City of Parramatta	
File No:	DA/405/2023

SECTION 4.15 ASSESSMENT REPORT Environmental Planning & Assessment Act 1979

DA No:	DA/405/2023
Subject Property:	LOT 22 DP 16064, 140 Alfred Street, HARRIS PARK NSW 2150
Proposal:	Construction of new single storey residential dwelling with included attic.
Date of receipt:	17 July 2023
Applicant:	McDonald Jones Homes
Owner:	Ms L T Roumanous
Property owned by a Council employee or Councillor:	The site is not known to be owned by a Council employee or Councillor
Political donations/gifts disclosed:	None disclosed on the application form
Submissions received:	No (0) Submissions
Recommendation:	Approval
Assessment Officer:	Caitlin Hopper

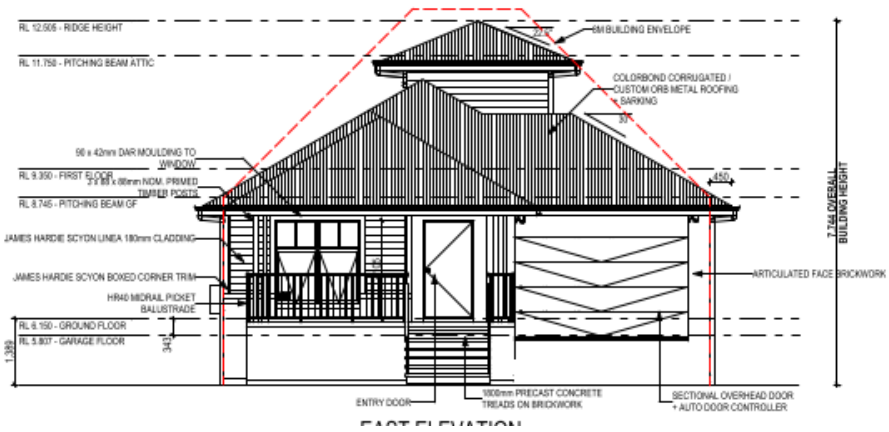
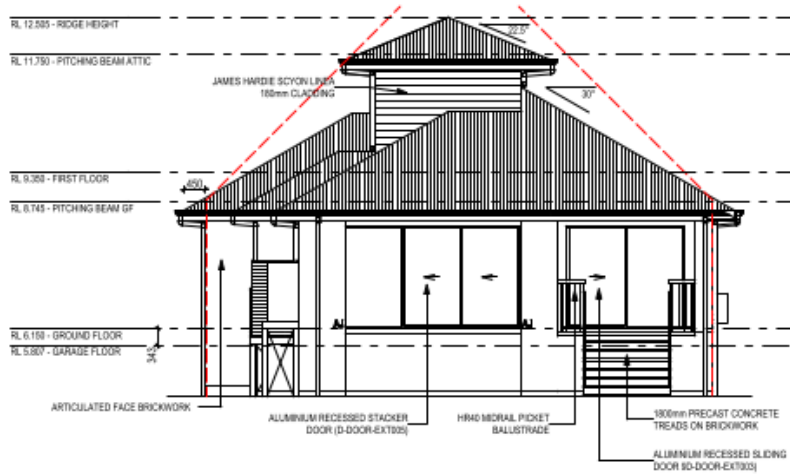
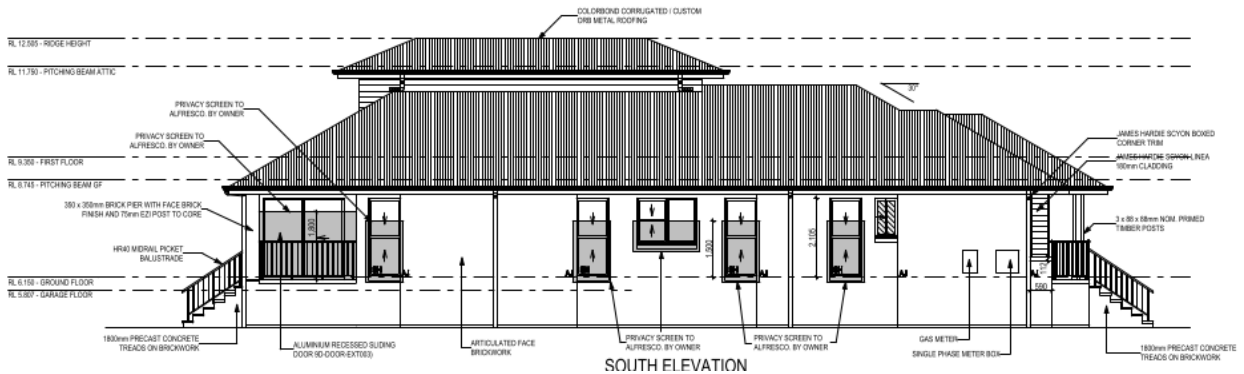
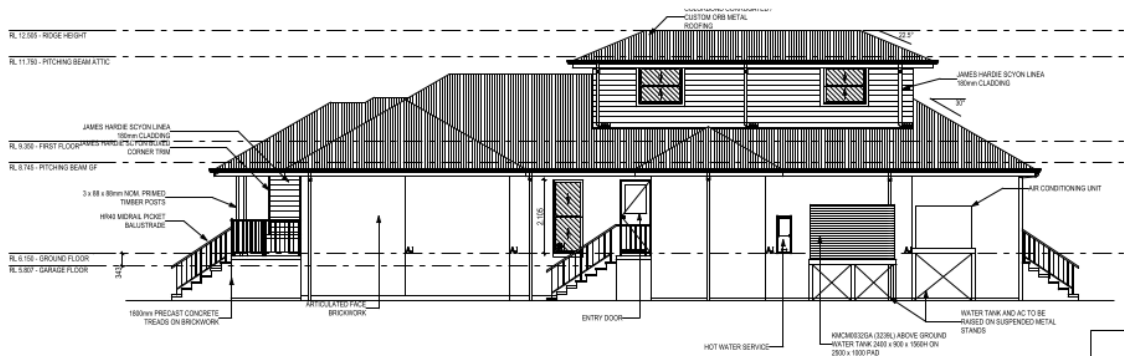
The proposed development for the construction of new single storey residential dwelling with an included attic. The proposed development includes a variation (of 1.505m or 13.7%) to Clause 4.3 Height of Buildings under the Parramatta

Local Environmental Plan 2023. The extent of the variation to the RL11m height control applies to the attic addition proposed towards the rear of the dwelling to meet the flooding requirement of the site and provide refuge above the PMF level.

Given that the proposal remains predominately single storey with the exception of the attic space, the proposal is considered to appropriately mitigate visual bulk and scale towards surrounding areas. The proposal also reasonably responds to the land constraints that exist and are unique to the site within the streetscape context. In this instance it would be considered unnecessary to enforce numerical compliance, therefore Council is satisfied the variation to the control is reasonable and the proposal as a whole is acceptable.
